Combined Victorian Society Testimony for July 30, 2024: Central Park - Harlem Meer -Scenic Landmark (LPC-24-11791); 44 Jane Street (LPC-24-08313); 829 Park Avenue (LPC-24-10852); 119 Fifth Avenue (LPC-24-08557); 99 Clinton Street, aka 152-156 Remsen Street (LPC-24-05234); 229 Waverly Avenue (LPC-24-06569)

Approximate time: 9:30; join Zoom by: 9:30 LPC-24-11791 -- Central Park - Harlem Meer - Scenic Landmark, Manhattan

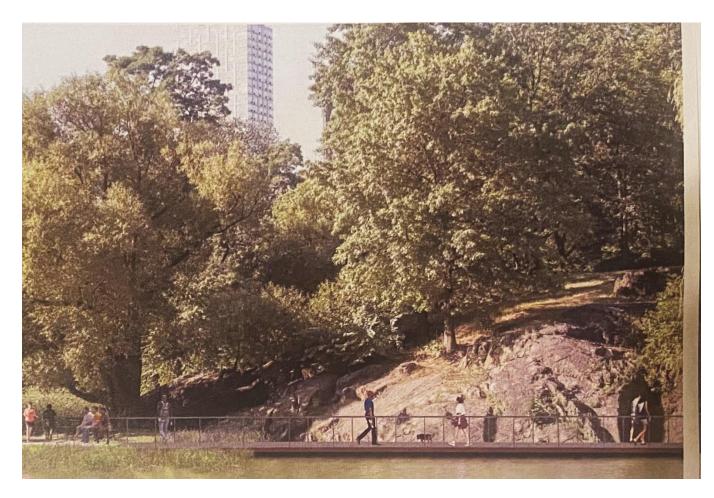
The existing south shore soft-surface walkway is nearly hidden by the shore vegetation, allowing the landscape to appear to cascade into the water.

By contrast, even without its metal and mesh railing, the boardwalk interrupts this view, separating the water from the landscape, and introduces a jarring, modern element.

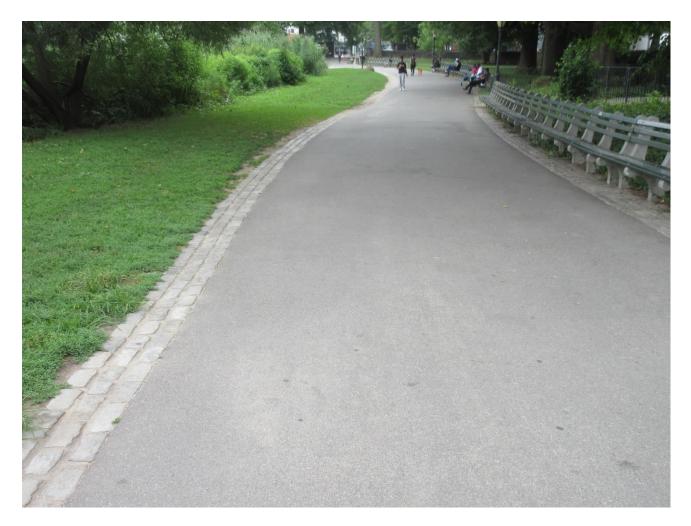
The two-dimensional photo only hints at the extraordinary experience of walking on this soft surface path at the water's edge, an experience unlike any other in the park. The visitor truly experiences *rus-in-urbe*. The removal of these paths would be a tragedy.

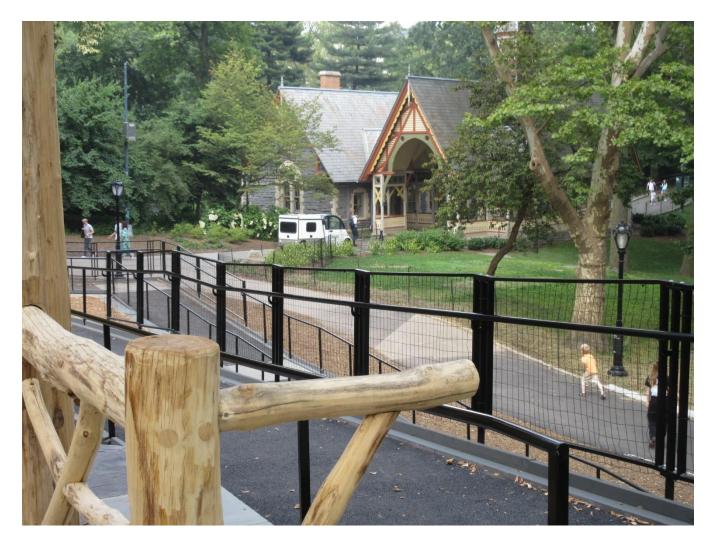
These cobblestone swales, installed in the mid-1990's renovation, mimic historic treatments when path edges were necessary. The single courses of raised granite blocks proposed to replace them, used elsewhere in the park, are more akin to modern street curbs. The swales produce a softer, less engineered edge.
